**FINAL DRAINAGE REPORT  
FOR  
SADDLEHORN RANCH – FILING 2**

**November 18, 2022  
Project No. 25142.04**

**El Paso County PCD File No.:  
SF-21-033**

## DP 9 Swale (100-Year)

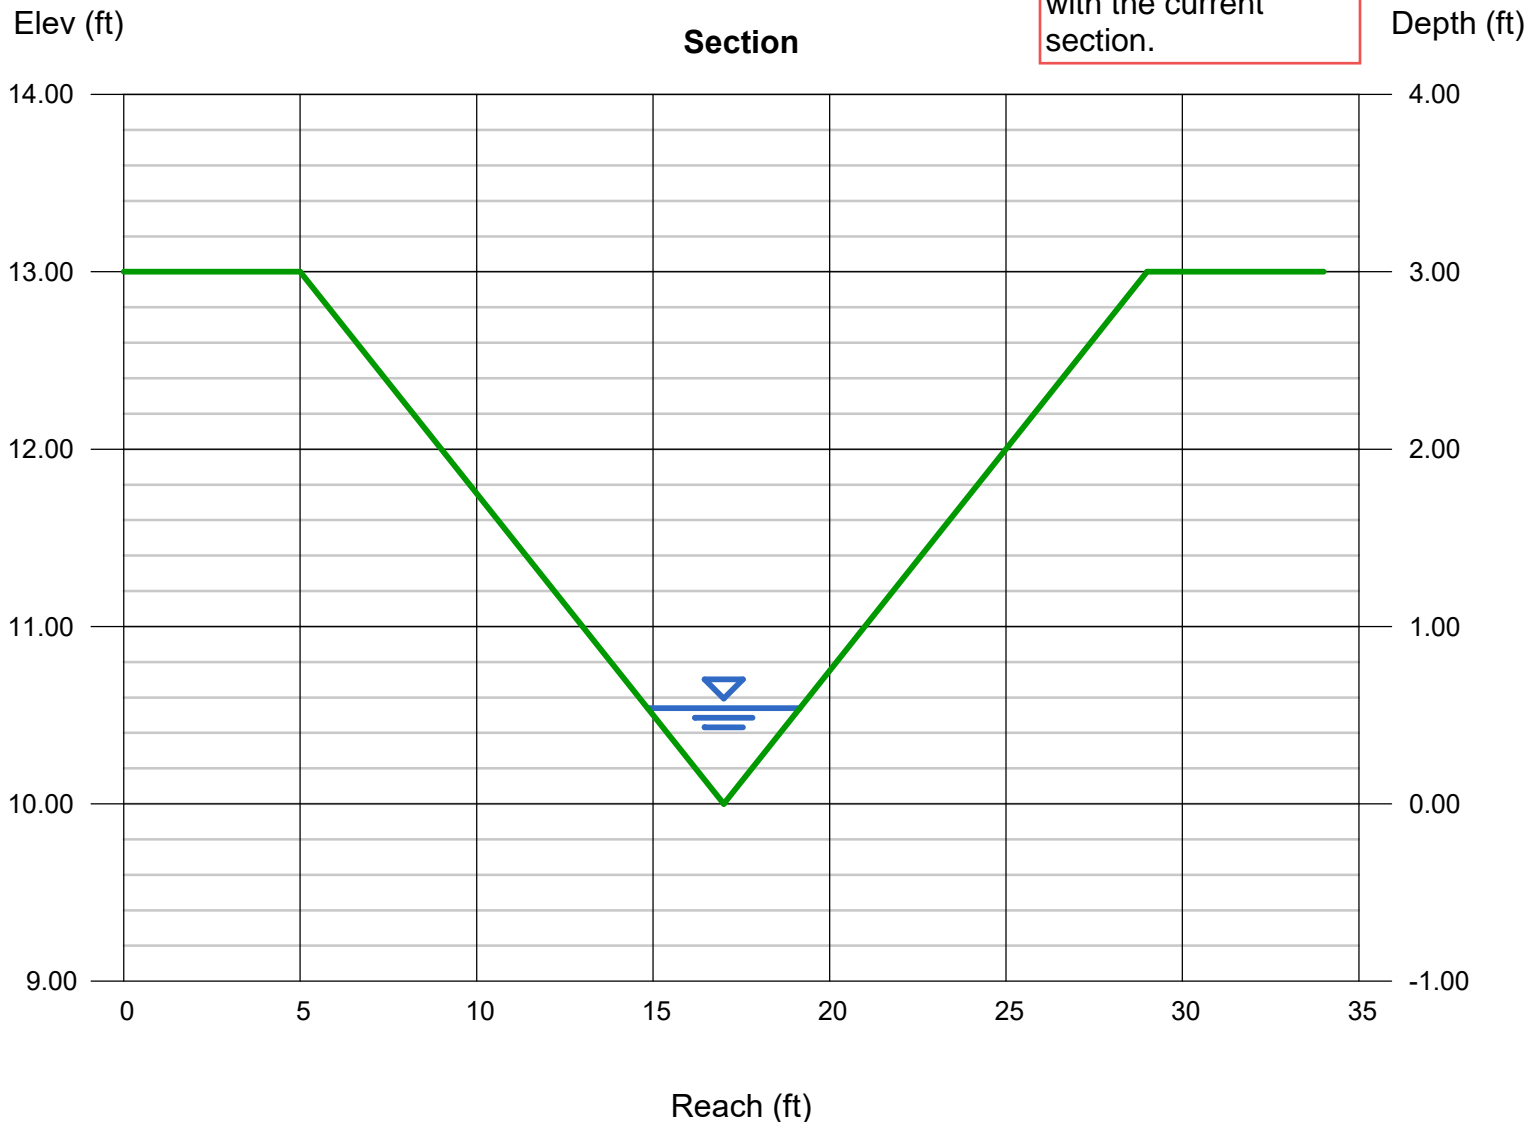
Replace Fr values on these sheets

Revise CDs and GEC plans for these changes

Fr values added to these sheets.

No changes were made from the GEC plans, this section was outdated and has been replaced with the current section.
